SUBJECT: CALLAWAY PLANT - NRC EXAMINATION REPORT 05000483/2007301

EXAMINATION REPORT
U.S. NUCLEAR REGULATORY COMMISSION
REGION IV

ER 05000483/2007301; November 26 through December 7, 2007; Callaway Plant; Initial Operator Licensing Examination Report.

Figure-1

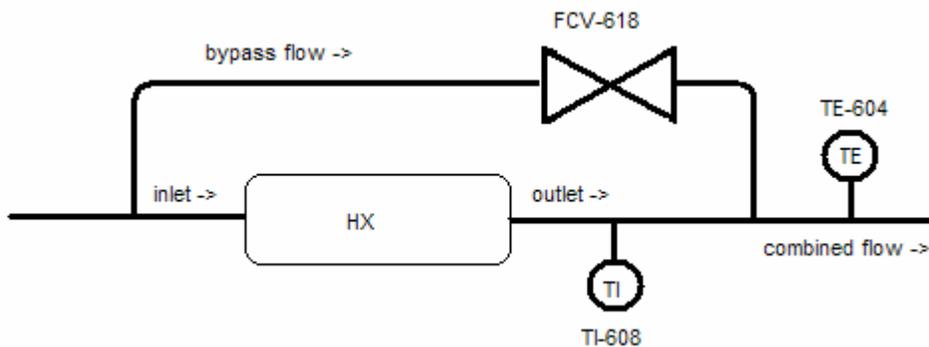
The licensee recommended accepting two answers, B and C, on the basis of the following information:

The question supposes Valve FCV-618 completely fails closed (air supply is lost) and asks the applicant to predict both the effect in total RHR flow and the effect on the “RHR HX Outlet Temp.” However, the question fails to differentiate between the local temperature indication for “RHR HX Outlet Temp.” on TI-608 and the control room indication for “RHR HX Outlet Temp.” as detected by TE-604. An analysis of the effect on the system of FCV-618 failing closed easily concludes that “Total RHR Flow” will be lower, while the temperature indicated on TI-608 will be higher and the temperature indicated on TE-604 will be lower. Therefore, since the question failed to define whether “RHR HX Outlet Temp.” was intended to refer to TI-608 or TE-604, the applicant could have reasonably assumed either temperature indication and therefore could have reasonably and correctly chosen either Answer B or C.

NRC Response for 3: The NRC agrees with the licensee's recommendation to accept both answers B and C since both answers are simultaneously correct depending on which temperature indication the applicant assumes is meant by “RHR HX Outlet Temp.”
